Traffic Commission

A G E N D A

TRAFFIC COMMISSION MEETING

June 13, 2018 at 6:30 p.m.

Table 4: Centennial Greenway at Delmar Crossing Synchro Concept B/C Conditions LOS Results

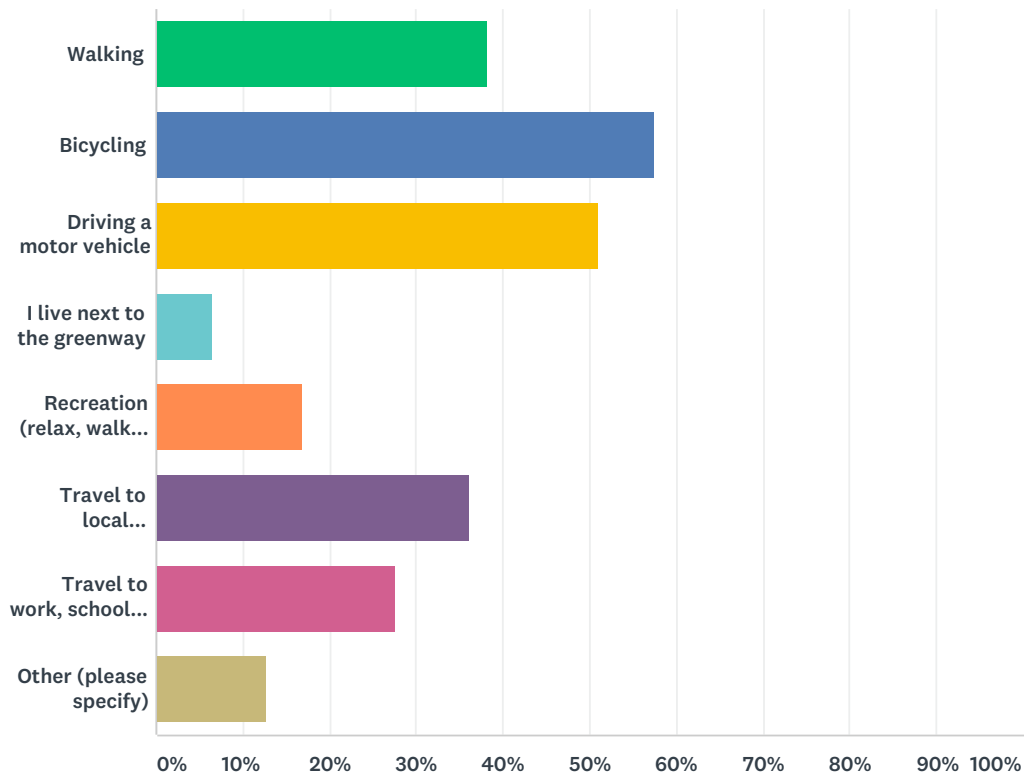
With the proposed road diets along McKnight Road and Delmar Boulevard, in addition to the proposed concepts B and C showing a bicycle and pedestrian crossing of McKnight Road at the I-170 On-ramp with an exclusive crossing phase, the intersections are still expected to operate at an acceptable LOS D or better.
